**FINAL
ENVIRONMENTAL IMPACT ASSESSMENT**

**JOINT CANNERY OUTFALL PROJECT
PAGO PAGO HARBOR
AMERICAN SAMOA**

**CH2M HILL
6425 Christie Ave
Emeryville, CA 94608
(415) 652-2426**

October 1991

FIGURE 3-5
LOCATION AND SIZE OF THE
REQUESTED ZONE OF MIXING

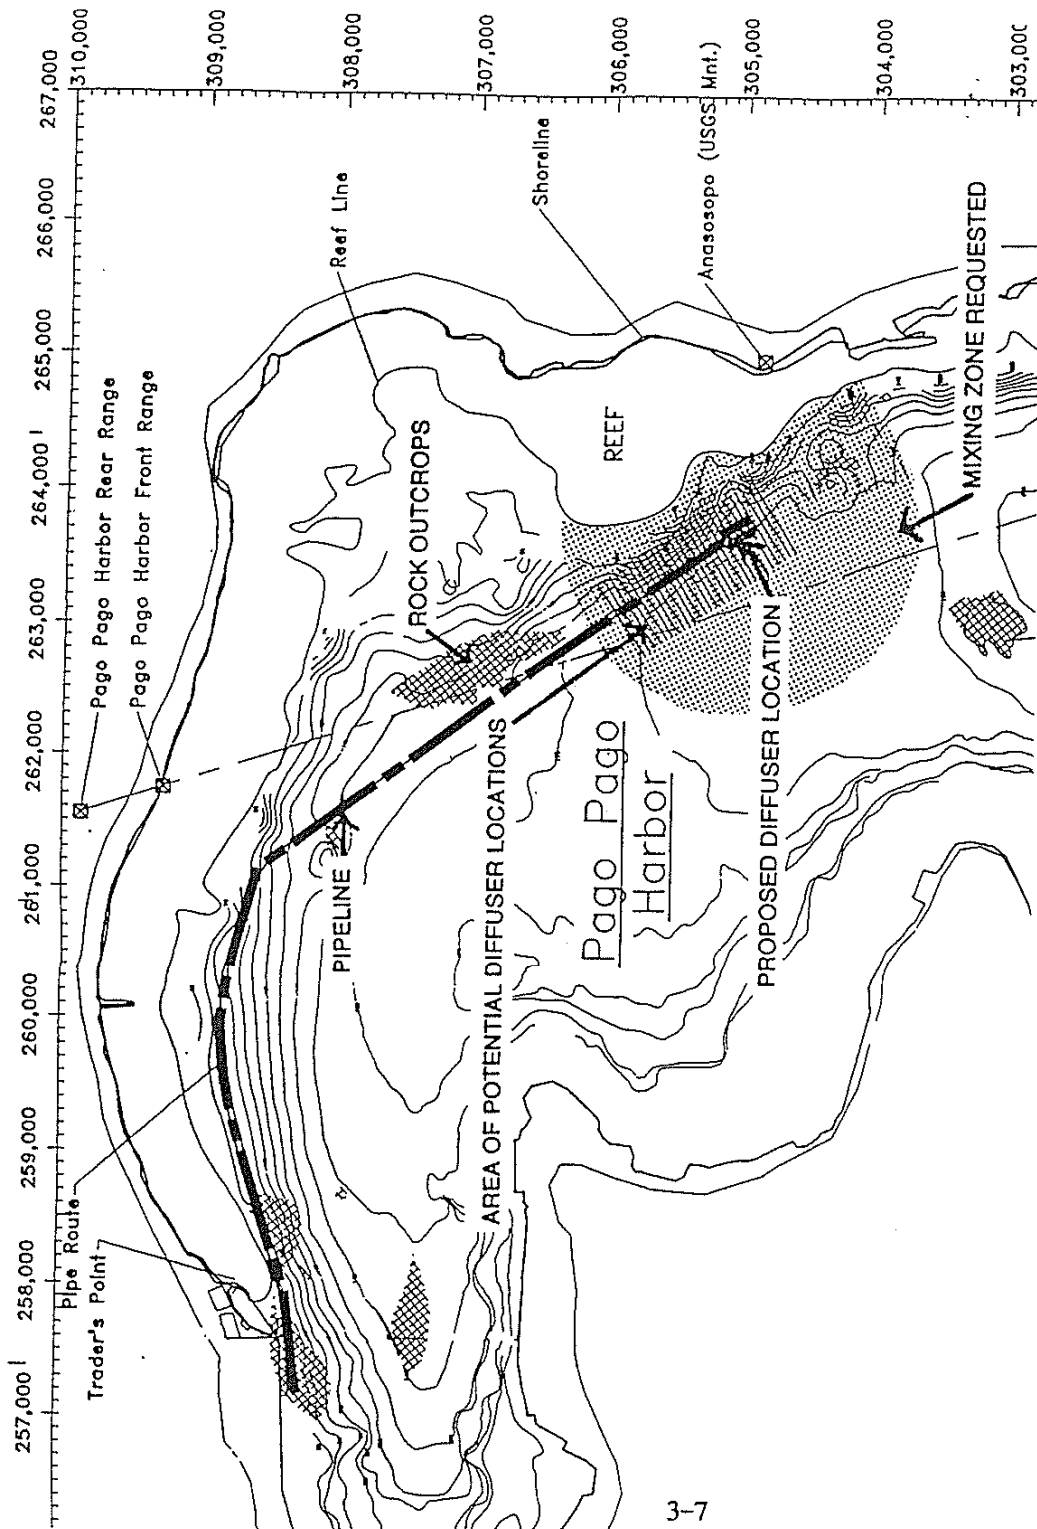
3 The Water Quality Standards also state that *"No part of shoreline or barrier or fringing reef shall be included in any zone of mixing"*. From the public hearing it appears that the proposed zone of mixing which will be required clearly abuts the wall forming the reef. It is unclear to me that the plume and the captured discharge will not impact the reef wall even though the plans and the model show that the plume will remain submerged. This is another reason to extend the line and move it further away from the reef line. (see attached)

Please see response to comments 2-1, 2-6, 2-7, and 2-9.

Figure 3-5 of the DEIA (attached to this comment letter) shows a region of potential diffuser locations. This area was determined as described in the excerpt below taken from the mixing zone application:

The requested zone of mixing is located offshore of the eastern shoreline of the harbor between Anasosopo Point and Ava Point. The center of the diffuser (center of the zone of mixing) is approximately at Northing 305,100 and Easting 263,700 as shown in Figure 1. This location may change slightly during final design and construction. However, the center of the mixing zone will be within the limits for potential diffuser locations shown on Figure 1.
